Snowdonia Aerospace Airspace Change Proposal Design Principles (Stage 1B), ACP-2019-58 Llanbedr Aerodrome Danger Area (DA)

Annex 1 - Supporting Evidence

This document provides supporting evidence as an annex to the "Stage 1B Design Principles" element of the Snowdonia Aerospace LLP submission for an Airspace Change Proposal, Reference: ACP-2019-58, Llanbedr Danger Area (DA), under the Civil Aviation Authority (CAA) CAP1616 Airspace Change Process.

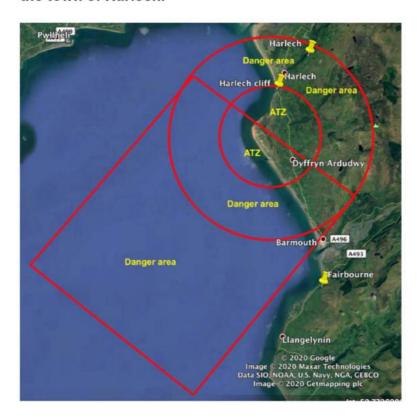
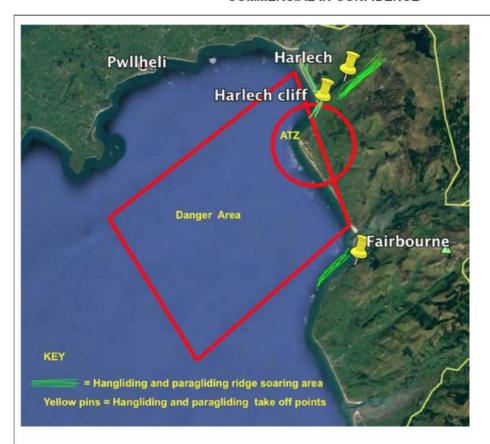
8. Please provide details of any constraints the introduction of this design may have on gliding, microlight flying, hang gliding, paragliding or model flying.		
Your response		
Snowdonia Sky Sport re Hang-gliding and p	s's (SSS) comment on the pa aragliding.	roposal ACP-2019-58

The attached map shows the position of three hang gliding & paragliding sites (yellow pins on the map) that would be made unavailable by the proposed new danger area centered on LLanbedr airfield ref. ACP-2019-58. Particularly, the proposed danger area would prevent take off and soaring flight from Harlech main take-off, Harlech Cliff take-off, and the dunes that extend north along the shoreline from the town of Harlech.

Also the proposed new danger area would limit and possibly prevent the use of Fairbourne take-off for hang gliding & paragliding as the danger area extends very close to the shore just in front of the main hill take-off for Hang-gliders/paragliders at Fairbourne.

Hang-gliding and paragliding has been recorded at these sites for over 30 years. Losing these launch points and the open airspace above them would be a significant loss for the local hang-gliding & paragliding community, and negatively impact tourism by making

Harlech and Fairbourne less attractive to visit for holiday-makers wanting to include paragliding/hang-gliding as part of their activities. For example, national level paragliding competitions are held at Harlech and the Rhinogs. These have made a significant contribution to tourism and farm diversification as local farmers hosted the competitions and provided camping accommodation and food facilities. In addition, other competitors booked their accommodation in Harlech town and environs. Fairbourne is currently used as an acrobatics training site for paragliders where pilots fly out over the sea to perform their maneuvers. This activity could also be prevented by the proposed danger area.
